**From:** Jason Sobel <jsobel@greenintl.com>  
**Sent:** Monday, October 16, 2017 10:01 AM  
**To:** Adam Duchesneau  
**Subject:** 700, 750, & 800 Mass Ave - sight distance follow-up  
**Attachments:** AASHTO sight distances.pdf; 10162017094821-0001.pdf

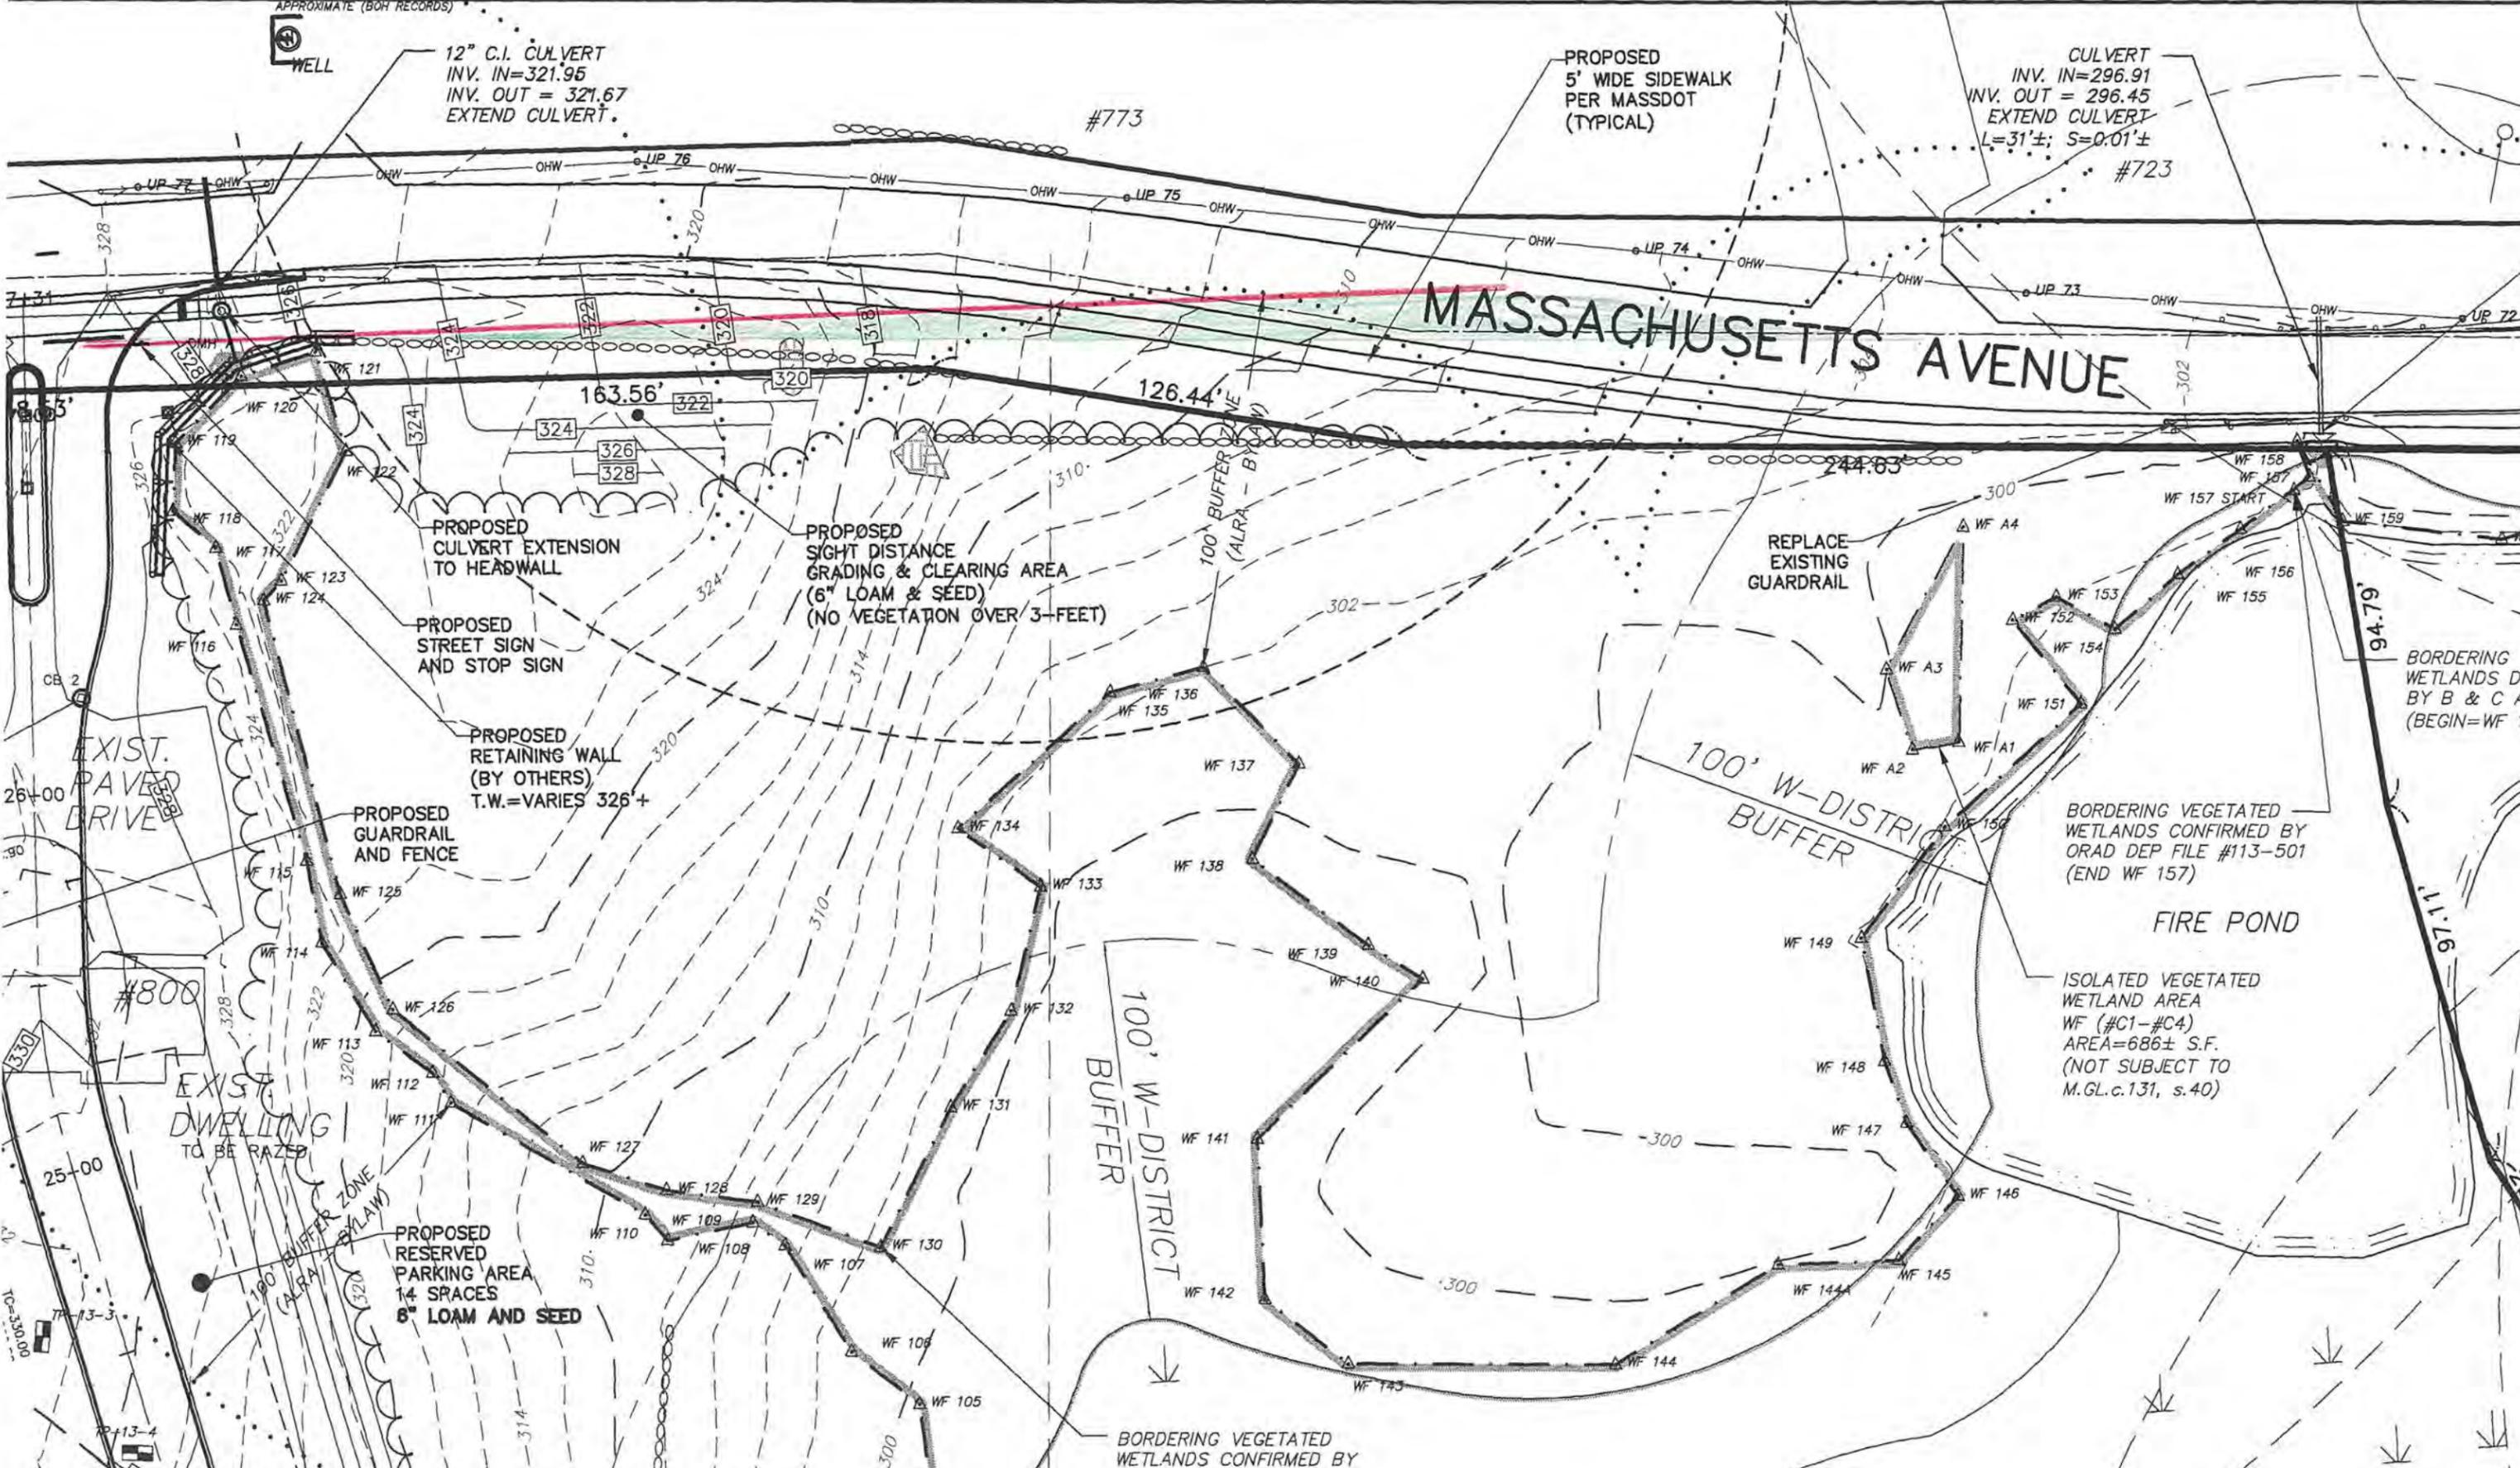
Available sight distance looking to the west = 375 ft

While the available sight distance does not meet the minimum required distance for vehicles traveling at the 85<sup>th</sup> percentile speed of 46 mph, the 375 ft does meet the minimum requirements for vehicles traveling at 44 mph, and of course also meets the minimum requirements for vehicles traveling at the posted speed limit of 40 mph.

Available sight distance looking to the east = 375 ft

The 375 ft of available intersection sight distance exceeds the minimum requirements for vehicles traveling at both the posted speed limit (40mph) and the 85<sup>th</sup> percentile speed (44 mph). Please also note that the 375 ft was estimated by the Applicant's traffic consultant and presented in the Dec 2016 traffic study for this project. The latest plans that I've seen (revised Aug 30, 2017) show that the area being re-graded and cleared to the east of the proposed driveway is more than sufficient to obtain the 375 ft of sight distance. On the attached PDF, the red line shows the 375 ft of intersection sight distance. The green shaded triangle behind the red line shows what would be needed to obtain the desirable distance of 485 ft (based on the 85<sup>th</sup> percentile speed). Based on the area to be regraded, as shown on this plan, the available sight distance looking to the west will be beyond the 375 ft estimated by the applicant's traffic engineer.

I hope this helps to clarify the sight distances. I apologize for not having the minimum/desirable distances looking to the east with me in the field on Friday. As we stated in our Sept 6, 2017 letter (comment #11), the area to be regraded/cleared on the plans is more than sufficient to provide adequate intersection sight distance looking to the east, and I thought that that issue was already resolved.
